URBAN DESIGN COMMITTEE

TO: **Urban Design Committee**

RE: Meeting of May 3, 2022

ITEM 2: Telegraph District Redevelopment Project

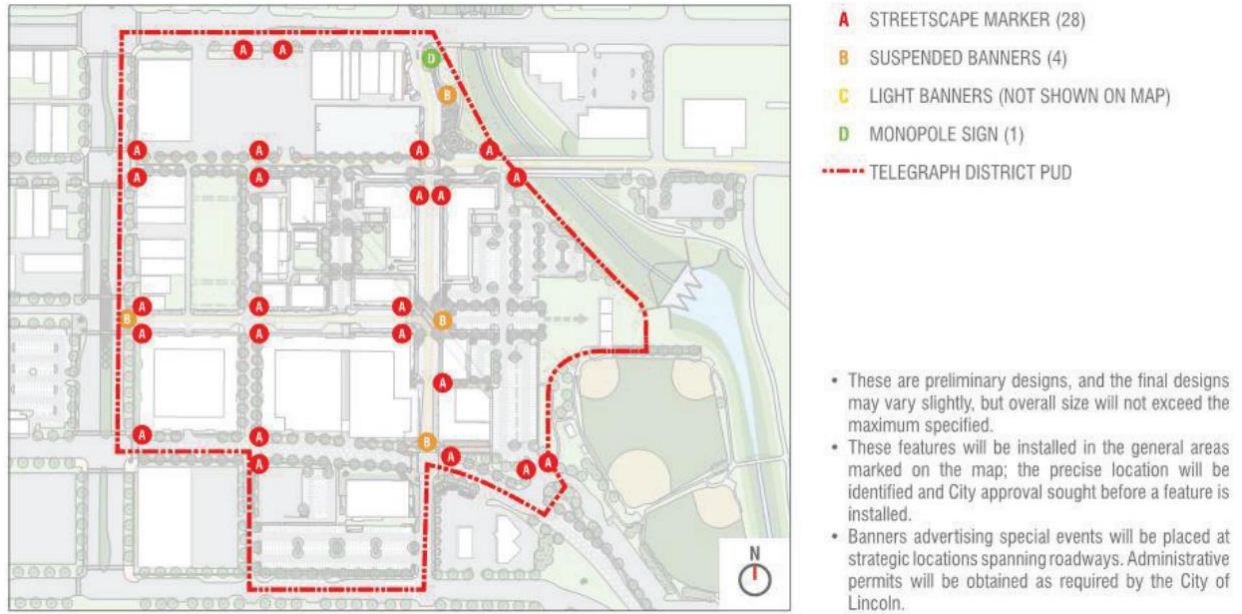
Developers are proposing to demolish the Telephone Museum building and create a parking lot on the north side of the garage building at 333 S 21st. Plans for the proposed parking area are attached for your review. Parking lot screening is proposed to match typical screening in the district. An example of the proposed screening (existing along K Street) is shown below.

According to the Design Standards for Screening & Landscaping, “Any on-site surface parking shall be paved and must be screened with plant materials, masonry walls, or masonry and metal (not chain-link) fences, or some combination thereof, to provide at least a 90% screen from grade to three feet above the grade.” The proposed screening, as noted by previous approvals, meets this standard.

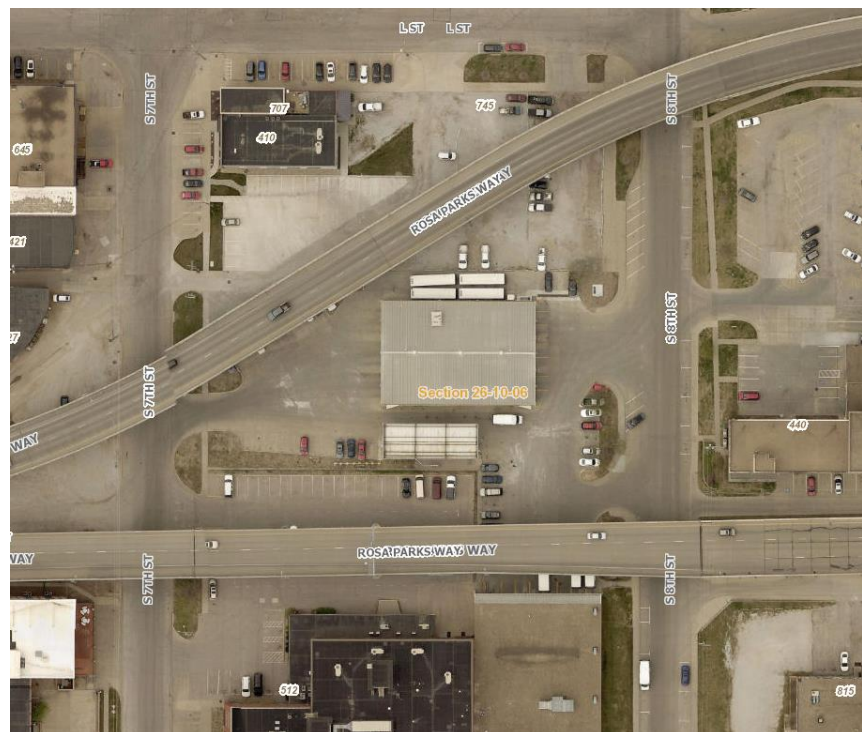
StarTran is proposing some changes to their Fueling Station between the Rosa Parks Way viaducts, from 7th to 8th Streets. The City is seeking your advice on this public project. An aerial view of the site is provided to the right, and the proposed site plan is attached.

TRUCK TURNING EXHIBIT

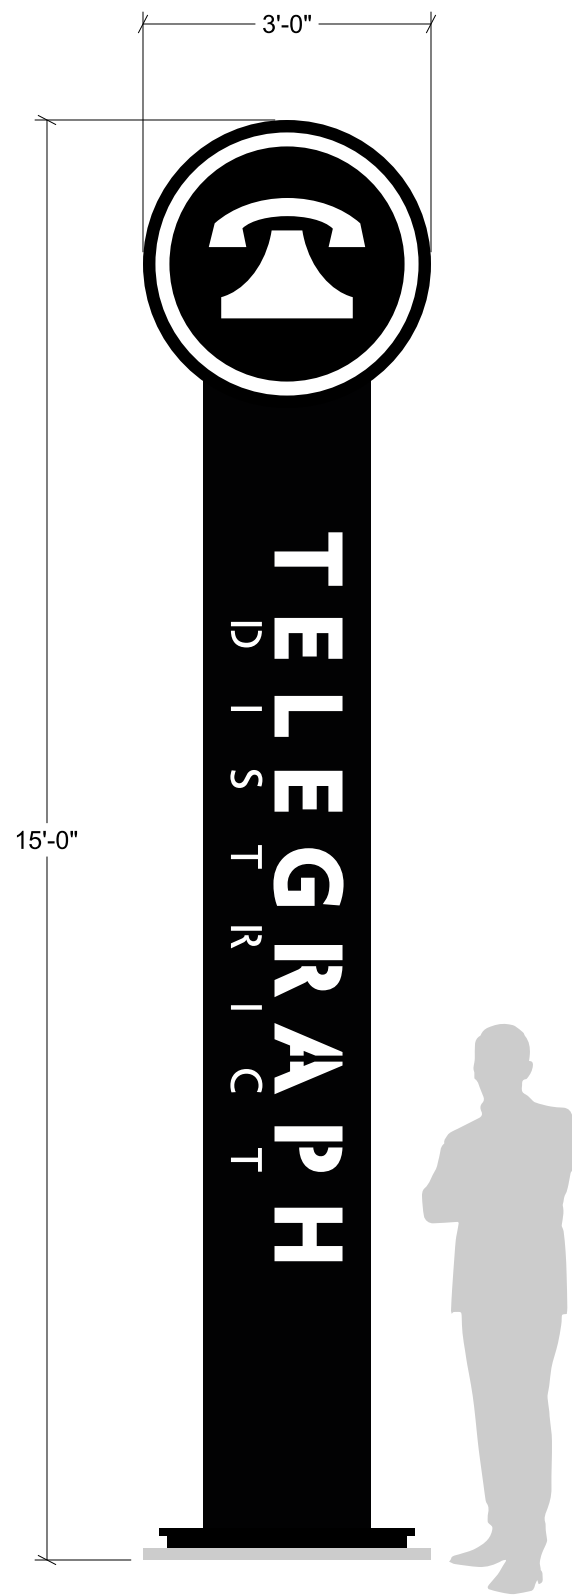
Allo will be moving some of their operations from the first floor space in the warehouse building to the west end of the garage building. Allo truck/van circulation is prompting a request for an additional vehicular entrance on the south, L Street side of the building. This is proposed to be a one-way in motion that complements the existing one-way out motion at the existing overhead door. Minor modifications for the building also include the addition of a couple doors and windows on the south side of the building. These proposed modifications are shown in the image below.

CLIENT EADO - Telegraph District
PROJECT Streetscape Markers Spring 2022
ADDRESS N St & S Antelope Valley Pkwy,
 Lincoln, NE 68508

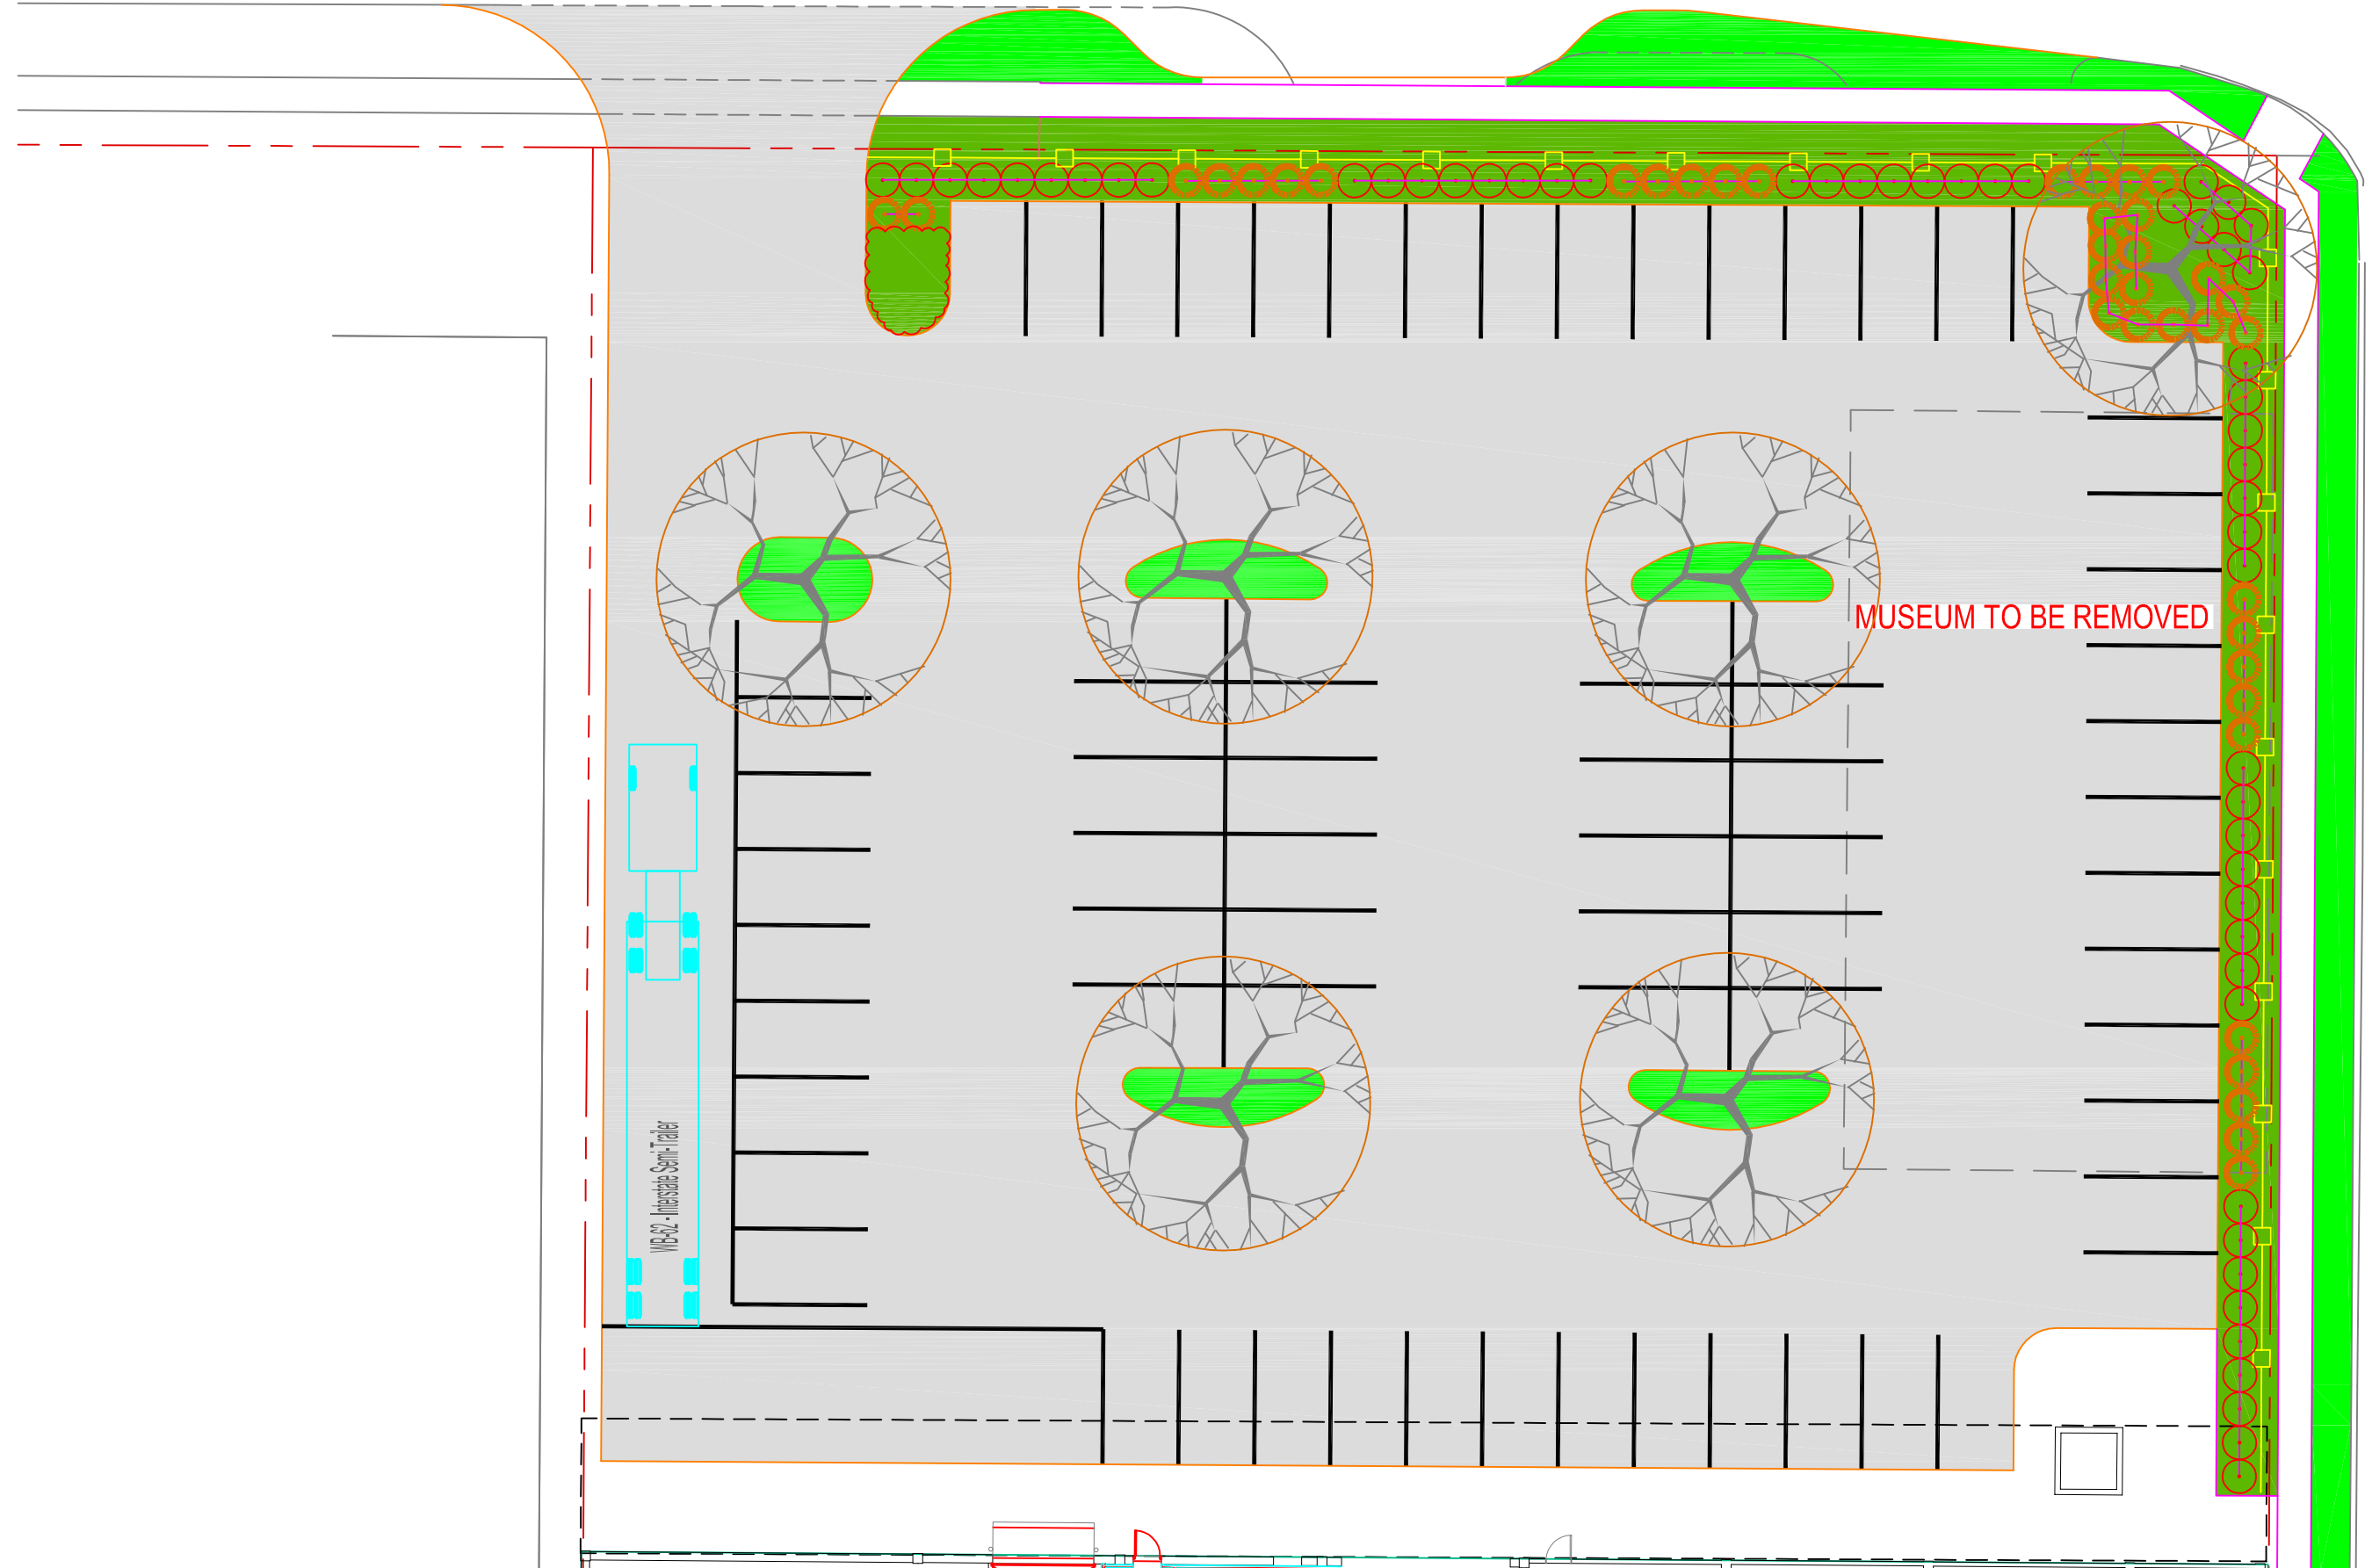
Because of limitations at these initial locations along Antelope Valley Parkway, developers are now proposing to locate streetscape markers in the Parkway's median. New locations are illustrated in the birdseye view below. Streetscape marker details are attached.

The proposed locations are located outside of the Telegraph District PUD boundary but are within adjacent public right-of-way. The City is seeking your advice on the appropriateness of this location. The original intent appeared to be using the streetscape markers as entryway elements into the Telegraph District, as the markers were shown on both sides of M and N Streets and on the north side of L Street. This new application seemingly expands the district to include the Antelope Valley Parkway corridor. Other considerations include the construction and maintenance costs associated with these markers.

Consideration should be given to the impact that the streetscape markers would have on this major north/south corridor and not just the Telegraph District adjacent to the east. For example, Antelope Valley Parkway is also considered an entryway into the University of Nebraska-Lincoln campus to the north.

City staff has been coordinating with UNL Landscape Services staff to design and install landscape improvements within these medians, and that work is expected to be completed this year. Planning for and installation of any streetscape markers should be coordinated with the anticipated landscape improvements.
